**81104A-05B**

# S E R V I C E N O T E

## 81100 Family Pulse Pattern Generators

**Intermittent display failures  
(shifting lines, inverted, fully lit or completely dark display)**

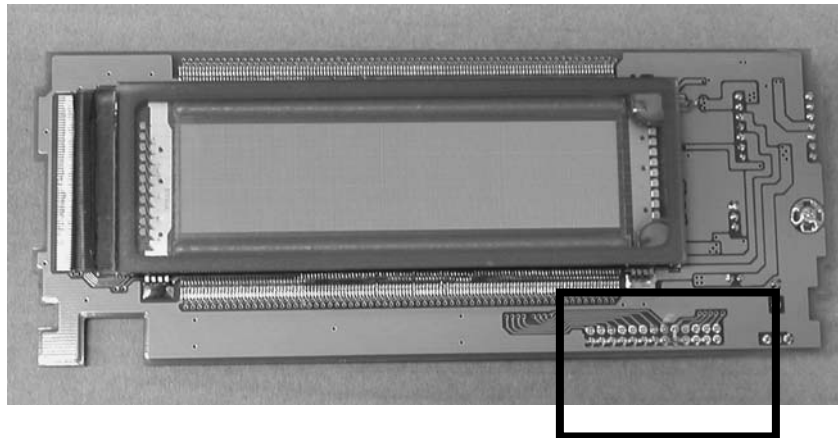
Intermittently the front panel display may show shifting lines that are falling back to their normal state. Additionally an inverted display, a display with all pixels lighted or a blank display may occur intermittently.

- Remove the front frame and unplug the connector cable from the 81100 mainframe.
- Carefully remove the display module from the front frame and check for a capacitor that might have been added during an earlier intermittent modification (see picture below). If there is such a capacitor, unsolder it from the module. Re-install the display into the front frame.

- On the 81100 mainframe replace the existing filter plate with the new filter plate, p/n 0960-0996. The new filter plate can be identified by a single connector pin that shows a red color code.
